Subject: Opposition to proposed Villas-III development plans at 100 Callahan Way

Subject: Opposition to proposed Villas-III development plans at 100 Callahan Way

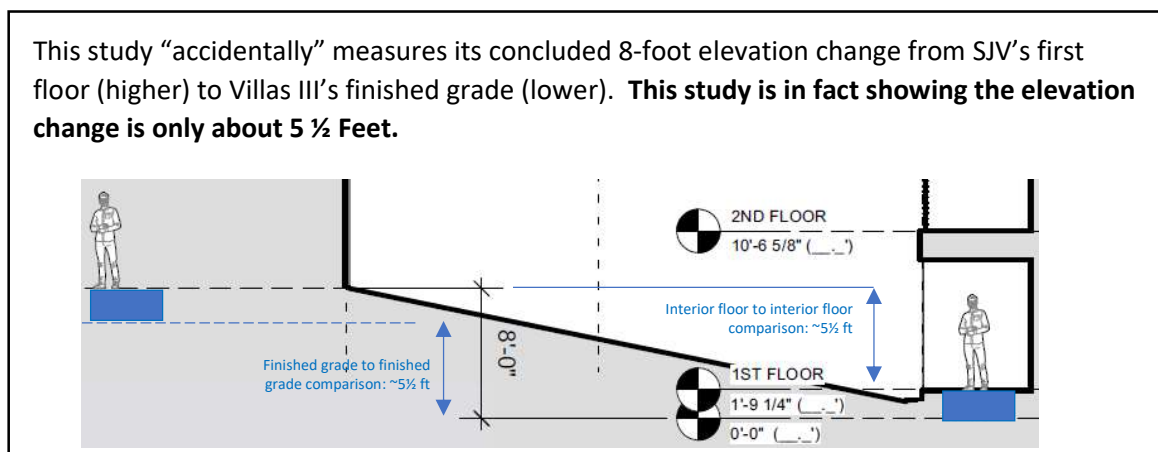
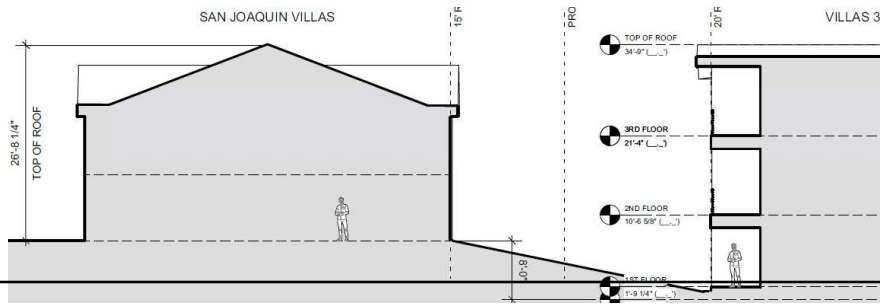
Additionally, this study **misrepresents the relative height** between the SJV E-building and Villas III duplexes by using inconsistent reference points between the two structures. Maximum building height is measured from the finished graded adjacent to the building exterior to the highest roof peak. This “study” does not use “apples-to-apples” references. Both structure heights should be measured from finished grade (indicated by horizontal blue dashed line on SJV image, and the zero-reference on the Villas III image).

By misrepresenting both the SJV image proportion and the incorrect height reference point, this “study” attempted diminish the actual impact of the Villas III duplex 35-foot height.

This “study” also misrepresents the relative **Heights** of the SJV E Building and the Villas III duplexes (p. 69/74). It shows the tops of the 2 buildings to be the same height. It claims SJV is 26’- 8 ¼” and Villas III is 34’ - 9” tall. The actual difference in height would be 8’-3 ¾”. However, the previous paragraph proves that the Elevation Change is actually about 5.5’. Their error is almost 3’ in height, which is an **error of more than 10% relative to SJV’s height**.

Staff Report inclusion of this flawed study is another example of bias toward the developer. To rectify this egregious and deceptive attempt to sway benefit to the developer, I request the PEDC **require a fact-based Shadow Analysis be conducted by an independent entity using true and accurate building dimensions and spacing to factually represent the significant negative impact the Villas III Duplex units 22-25 will have on SJV (E-building) during the winter months.**

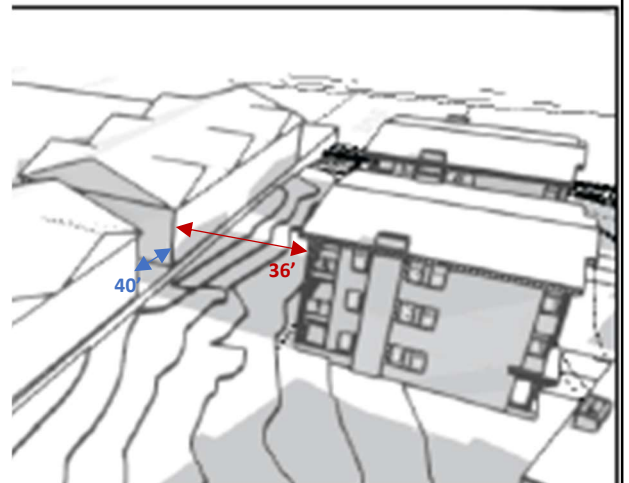
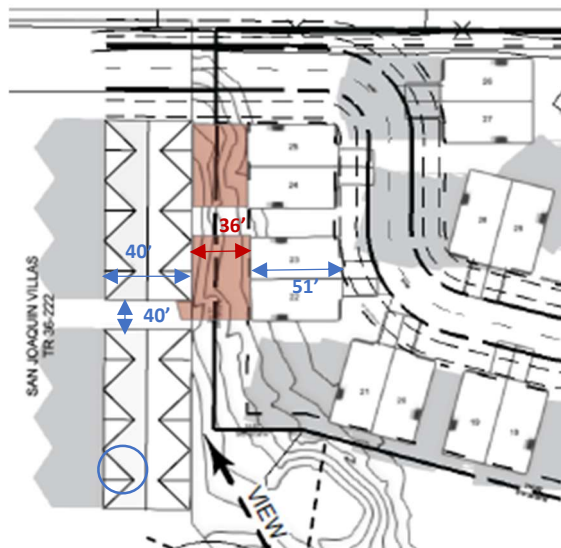
The **distances between buildings** are also misrepresented, as can be seen by the images below with the actual dimensions applied.

The distance between Villas III and SJV E-building (36’) is shown inaccurately as significantly larger than the distance between SJV’s E- and D-buildings (40’).

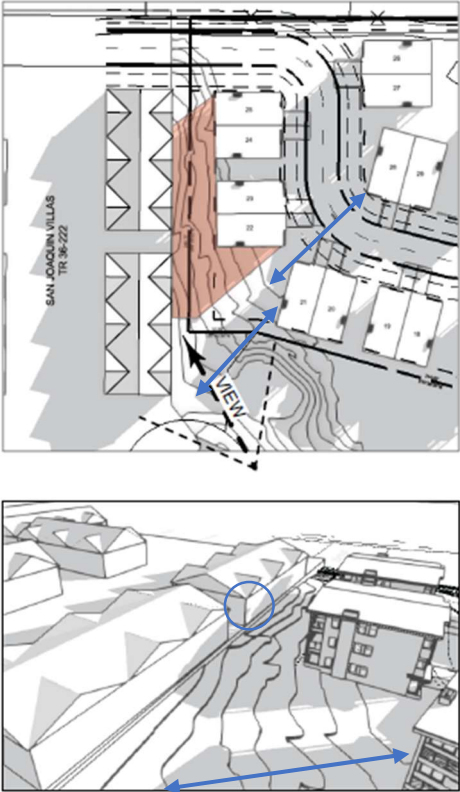
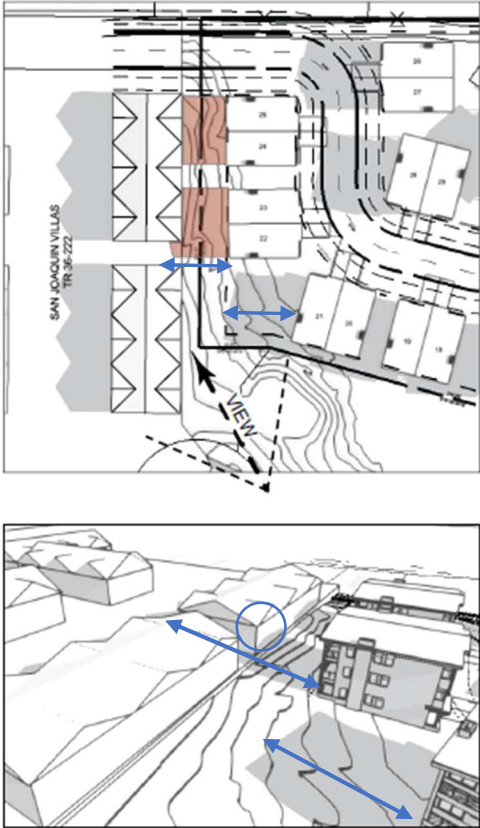
Further, these same “study” pages illustrate the significant size of the duplex shadows cast by the other duplex units and yet try to minimize that effect when the shadow strikes the SJV E-building.

<p>WINTER SOLSTICE, DECEMBER 21ST</p> <p>9AM</p>  <p>The Solar Study (Project Plans p.72/74) shows these Winter Solstice 9AM long shadows cast by Units 28 and 18-21 (blue arrows) are approximately 120 feet long. The (orange) indicates shadows cast by units 22-25 onto E-building.</p> <p>These Winter 9am shadows cast by units 22-25 (orange) will impact and overshadow SJV E-building and half of SJV D-building by a significant amount.</p> <p>Yet this simulated study inconsistently indicates my home will get sunshine during this long shadow period when units 22-23 are just 36' away ?? – inaccurate.</p>	<p>12PM</p>  <p>These Winter Solstice 12PM shadows cast by units 21 (shadow length indicated by blue arrow; note both shadow length and width) compared to units 22-25, which are the same size and would cast the same size shadow.</p> <p>The second blue arrow shows the length expected from units 22-25, however the lower image unexpectedly shows sun on the E-building when the unit 21 shadow length clearly indicates there would not be sun in this location.</p>
